# Access Compliance Report

## Public Rights-of-Way

### (Curb Ramps)

Intersection ID: 20422	Main Street: W_ARROWOOD_RD	Cross Street: S_TRYON_ST	Location: NW
ADA ID: B7F74D8D91D8	Ramp Type: Perp	Initial Pass/Fail: Fail	Overall Compliance: No
			Severity Score: 13.75

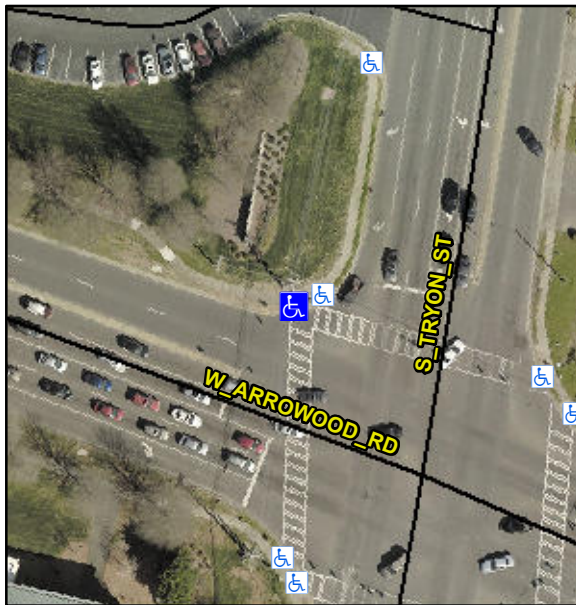
**Not Found, R304.2.2**

Compliance	Description	Data	Compliance	Description	Data
N/A	Ramp Length (in)	76.0	No	Ramp Slope (%)	10.2
Yes	Ramp Width (in)	48.0	Yes	Ramp XSlope (%)	2.4
N/A	Flare Type LT	N/A	N/A	Flare Type RT	N/A
N/A	Flare Slope LT (%)	N/A	N/A	Flare Slope RT (%)	N/A
N/A	Flare Traversable LT?	N/A	N/A	Flare Traversable RT?	N/A
N/A	Landing Length (in)	N/A	N/A	DWS Provided?	N/A
N/A	Landing Width (in)	N/A	N/A	DWS Contrast?	N/A
N/A	Landing Slope (%)	N/A	N/A	DWS Length (in)	N/A
N/A	Landing X Slope (%)	N/A	N/A	DWS Full Width?	N/A
N/A	Landing Curb? (Y/N)	N/A	N/A	DWS Offset (in)	N/A
N/A	Shared Landing?	N/A			
N/A	Gutter Ponding?	N/A	N/A	Gutter Slope (%)	N/A
N/A	Gutter Lip Ht (in)	N/A	N/A	Gutter X Slope (%)	N/A
N/A	Painted X Walk1?	Yes	N/A	Painted X Walk2?	N/A
	X Walk 1 Direction	To S		X Walk 2 Direction	N/A
N/A	X Walk 1 Width (in)	131.0	N/A	X Walk 2 Width (in)	N/A
	X Walk 1 Slope (%)	1.9		X Walk 2 Slope (%)	N/A
	X Walk 1 X Slope (%)	2.4		X Walk 2 X Slope (%)	N/A

**Remove & Replace Entire Ramp.  
Restripe Crosswalk.**
